To: Geoff Thompson
Chair IEEE 802.3
cc: Howard Frazier
Chair IEEE 802.3z

Subject: Operation of IEEE 802.3z GMII interface to continuous octet flow at 1 Gbit/s

Reference: Draft IEEE 802.3z/D5.0 - May 1998

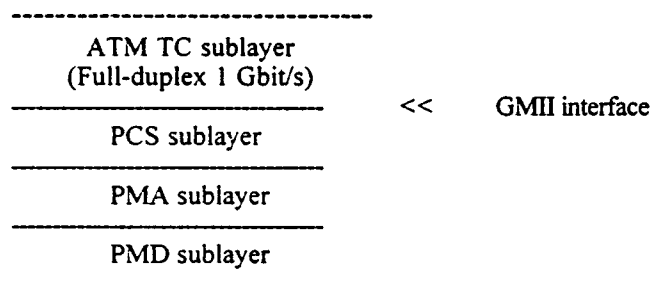
The proposed ATM TC sublayer shall interface with the GMII interface, as defined in clause 35 of IEEE P802.3z. The reference model we are considering is shown below:

From our understanding the GMII interface is defined to operate as a framed-based interface, and it is not clear if this interface can support a continuous gigabit cell/octet flow for point to point connection. The continuous octet flow comes from the fact that the ATM TC sublayer generates a continuous stream of cells; each cell has a fixed length of 53 octets. In the egress direction each cell is immediately followed by another cell, in respect with the transmit clock; there is no idle time between cells. Similarly, in the ingress direction, the ATM TC sublayer is expecting to receive a continuous octet flow from which ATM cells boundaries are recovered (by using the HEC checking).
